November 12, 2024

To: Greg Plucker
Colusa County Community Development Agency
Colusa County as Lead Agency for Janus Solar and Battery Storage Project

This document (and attached appendix) is for public comment on the DEIR related to Janus Solar and Battery Storage Project for which Colusa County Community Development Agency is the lead agency.

Imperial County California: 2012, ZOI factor

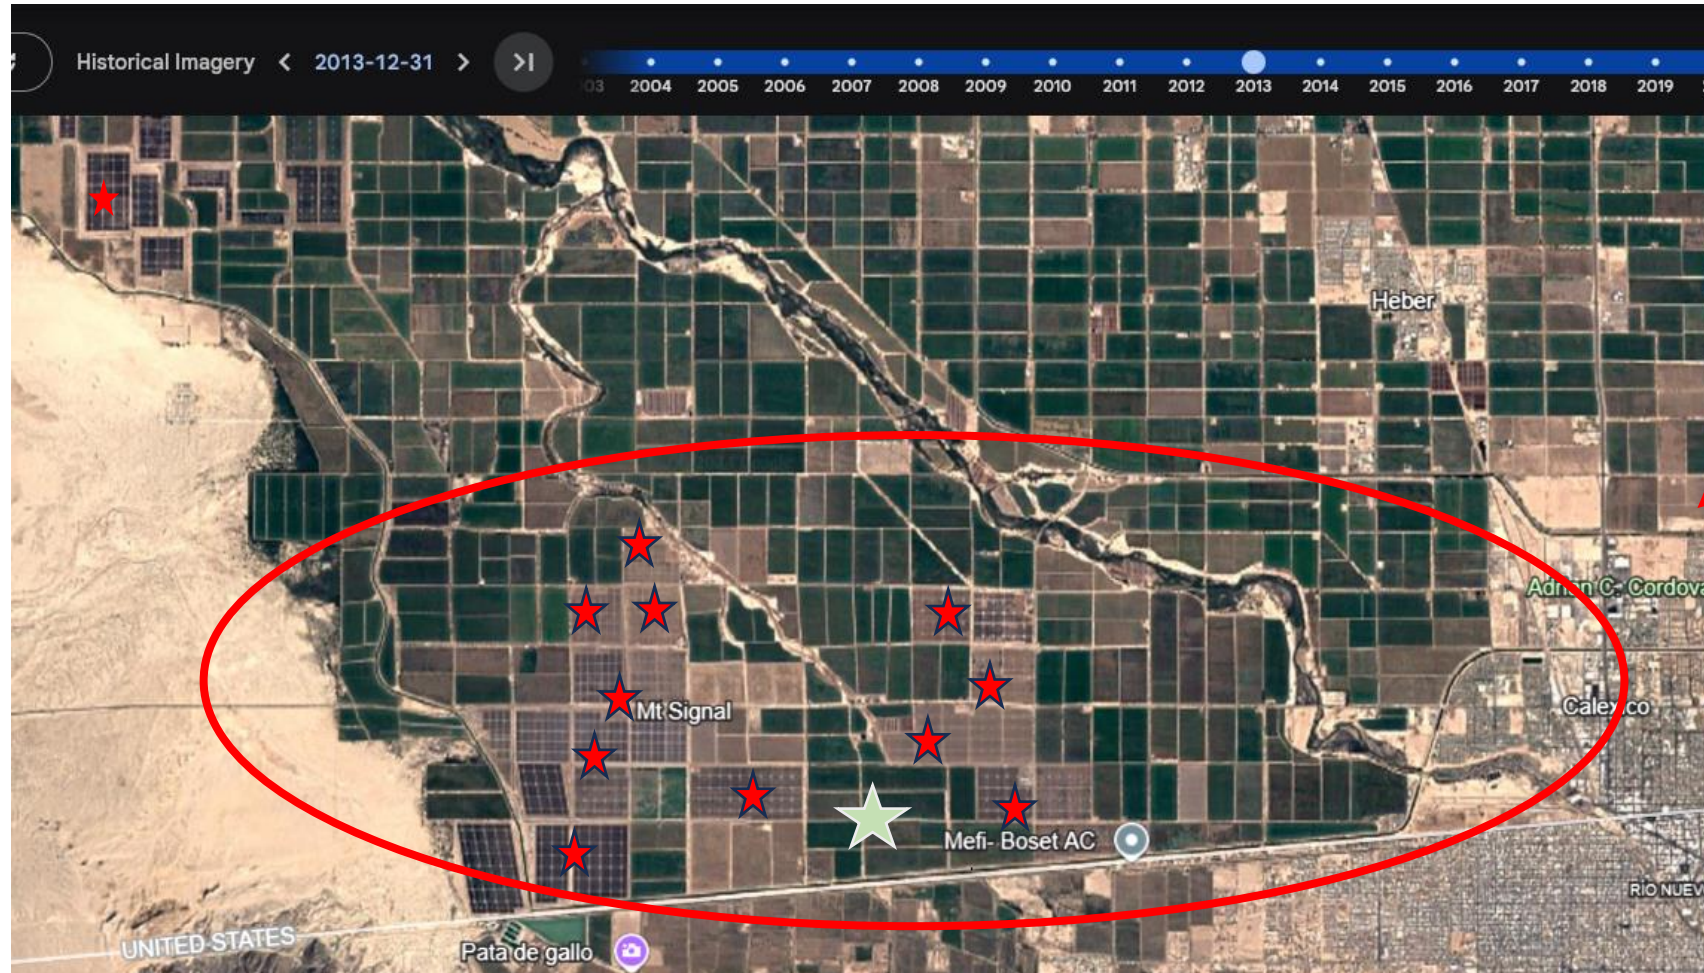
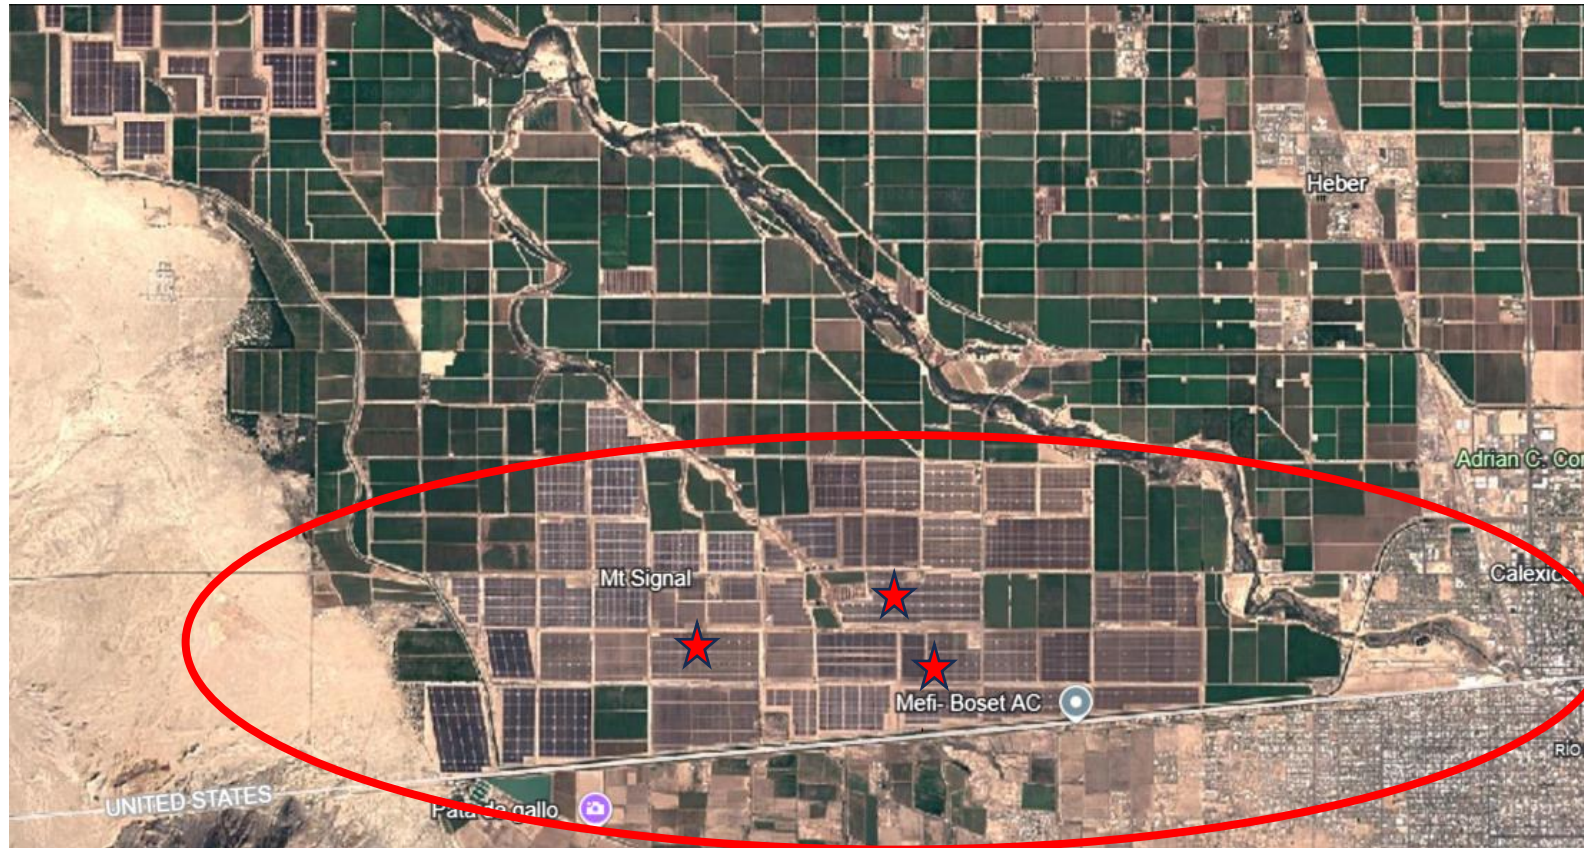
LESA model in DEIR fails to account for solar large scale developments zone of influence (ZOI).

Focus on
changing
landscape

Focus on
changing
landscape &
island of
farmland;

Focus on
changing
landscape:
Island of
farmland; **GONE**

Impact of Solar to Mount Orab, OH, from 2017 to 2022; LESA model in DEIR does not account for solar & ZOI.

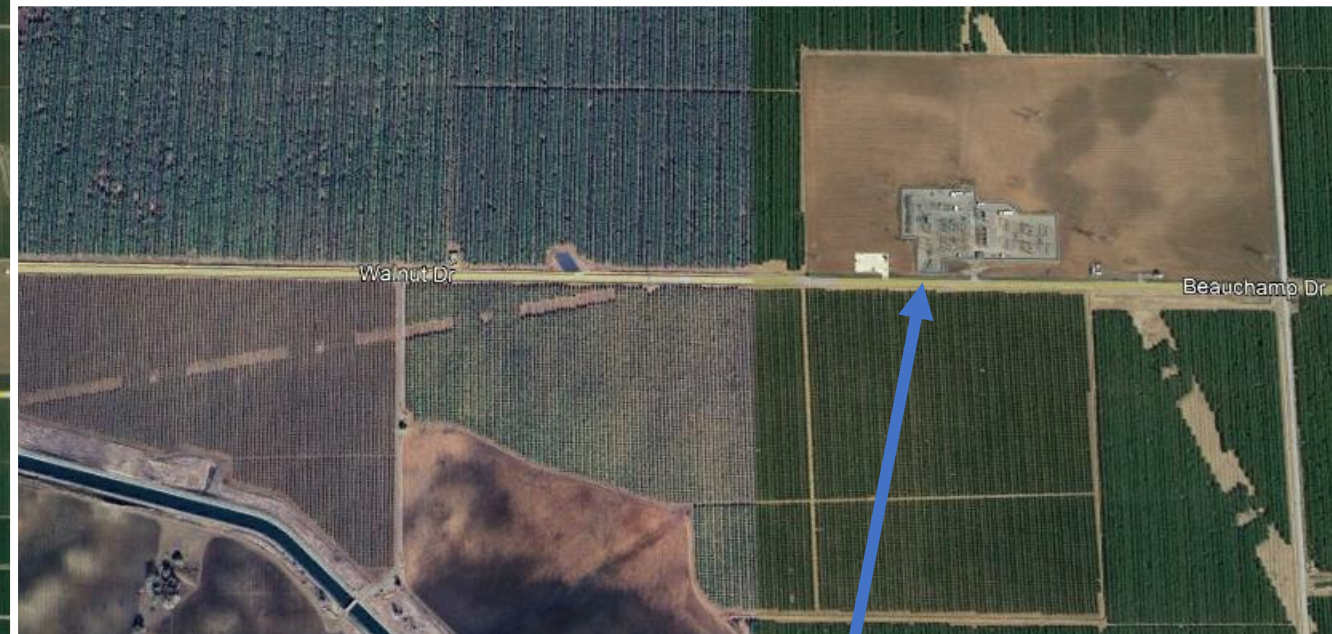
Last update (correction) to LESA model Appendices A and B (**dated 2011**) per [Conservation.ca.gov](https://www.conservation.ca.gov/); Does the DEIR modeling account for changes to solar development; what and how do factor weight impact analysis, ZOI, and are they current and being applied correctly?

- Any Permit, County General plan or ordinance needs to anticipate & correctly model impacts of utility size (large scale) solar developments occurring, particularly if there is a main electrical conduit, substation and/or Gen-tie in nearby.

Substation
on Walnut,
near Spring
Valley Road

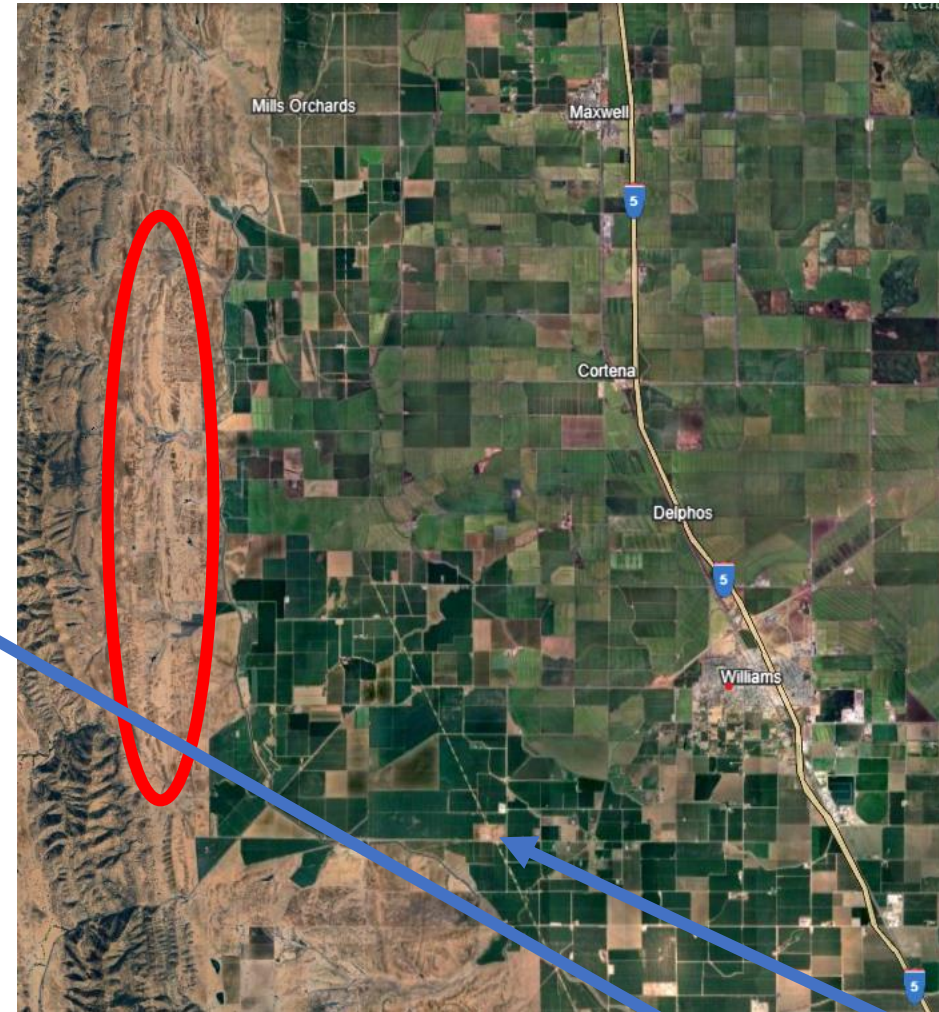
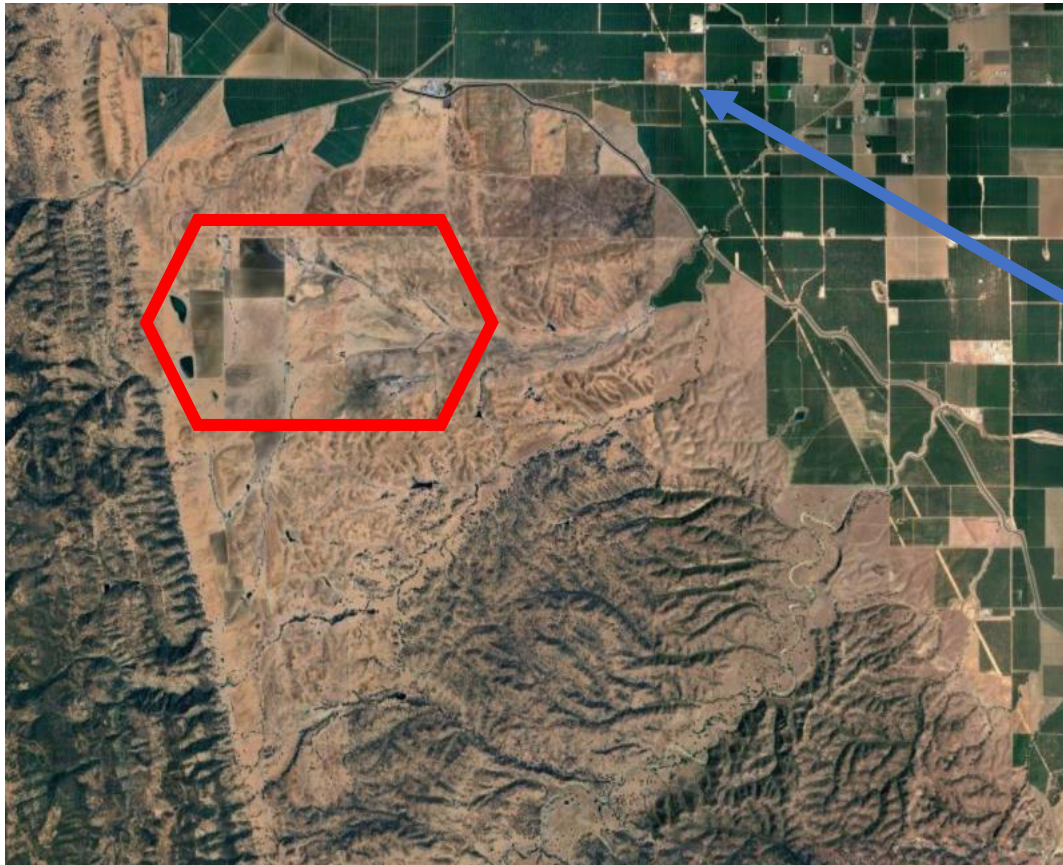
Red outlined areas may become solar lands and no longer farmland due to zone of influence by initial >600 ac solar facility and Gen-tie in; could also include south of displayed location below.
